Access Compliance Report

Public Rights-of-Way

(Curb Ramps)

Intersection ID: 10038854	Main Street: STEPHENSON_CT	Cross Street: N/A	Location: SE
ADA ID: 6273E4D3E387	Ramp Type: Perp	Initial Pass/Fail: Fail	Overall Compliance: No
Severity Score: 37.5			
Codes/Mitigation Info/Possible Solution		Field Measurements/Component Compliance

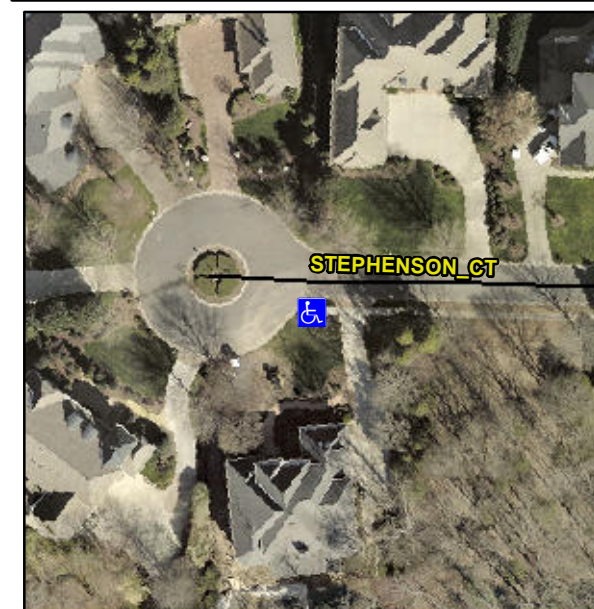
Not Found, R304.2.2, R304.5.3

Compliance	Description	Data	Compliance	Description	Data
N/A	Ramp Length (in)	49.0	No	Ramp Slope (%)	9.2
Yes	Ramp Width (in)	48.0	No	Ramp XSlope (%)	9.4
N/A	Flare Type LT	N/A	N/A	Flare Type RT	N/A
N/A	Flare Slope LT (%)	N/A	N/A	Flare Slope RT (%)	N/A
N/A	Flare Traversable LT?	N/A	N/A	Flare Traversable RT?	N/A
N/A	Landing Length (in)	N/A	N/A	DWS Provided?	N/A
N/A	Landing Width (in)	N/A	N/A	DWS Contrast?	N/A
N/A	Landing Slope (%)	N/A	N/A	DWS Length (in)	N/A
N/A	Landing X Slope (%)	N/A	N/A	DWS Full Width?	N/A
N/A	Landing Curb? (Y/N)	N/A	N/A	DWS Offset (in)	N/A
N/A	Shared Landing?	N/A			
N/A	Gutter Ponding?	N/A	N/A	Gutter Slope (%)	N/A
N/A	Gutter Lip Ht (in)	N/A	N/A	Gutter X Slope (%)	N/A
N/A	Painted X Walk1?	No	N/A	Painted X Walk2?	N/A
	X Walk 1 Direction	To N		X Walk 2 Direction	N/A
N/A	X Walk 1 Width (in)	N/A	N/A	X Walk 2 Width (in)	N/A
	X Walk 1 Slope (%)	2.6		X Walk 2 Slope (%)	N/A
	X Walk 1 X Slope (%)	6.0		X Walk 2 X Slope (%)	N/A

Remove & Replace Entire Ramp.
